**SUBJECT:** **NEW VEHICLE DEMONSTRATION / DELIVERY HOLD**  
**Compliance Recall 25C43 - Supplement #1**  
Certain 2024 and 2025 Model Year Mustang Vehicles  
Body Control Module (BCM) Water Intrusion Inspection

**REF:** **NEW VEHICLE DEMONSTRATION / DELIVERY HOLD**  
**Compliance Recall 25C43**  
Dated September 26, 2025

**New! REASON FOR THIS SUPPLEMENT**

**FIGURE 18**

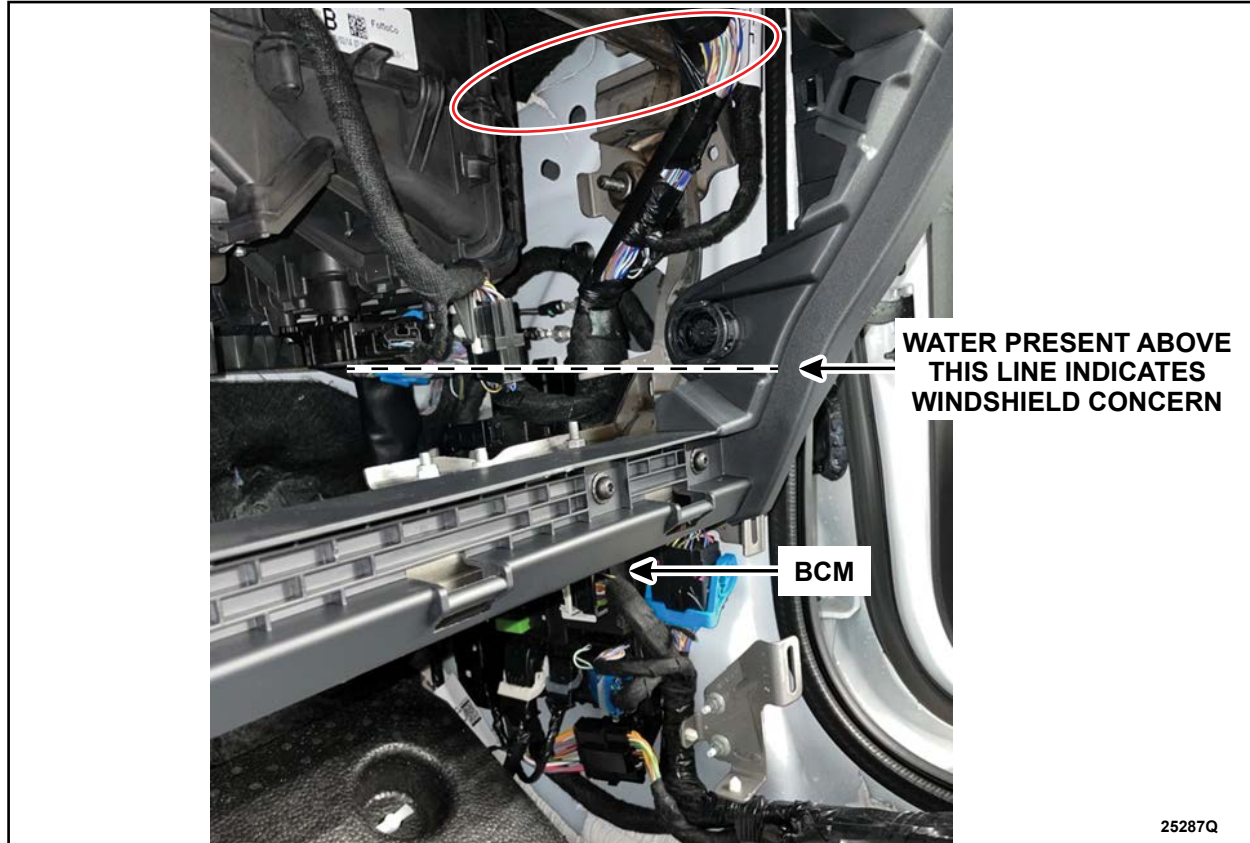
11. Is water present above the BCM? See Figure 18.

12. Inspect repaired seams for any pin holes or missed areas. If any seams were missed, repair them and repeat Step 1 of water testing. Is the unit still leaking?

**Yes** - Reseal the windshield. Follow WSM procedures in Section 501-11 (General Procedures > Fixed Glass). If windshield breaks during the reseal procedure, replace windshield. Have the service manager sign the repair order (RO), confirming that the windshield was removed and resealed OR replaced. Take a picture of the RO with the signature and the VIN visible. Contact the SSSC and submit the picture to obtain approval to claim 25C43C labor operation.
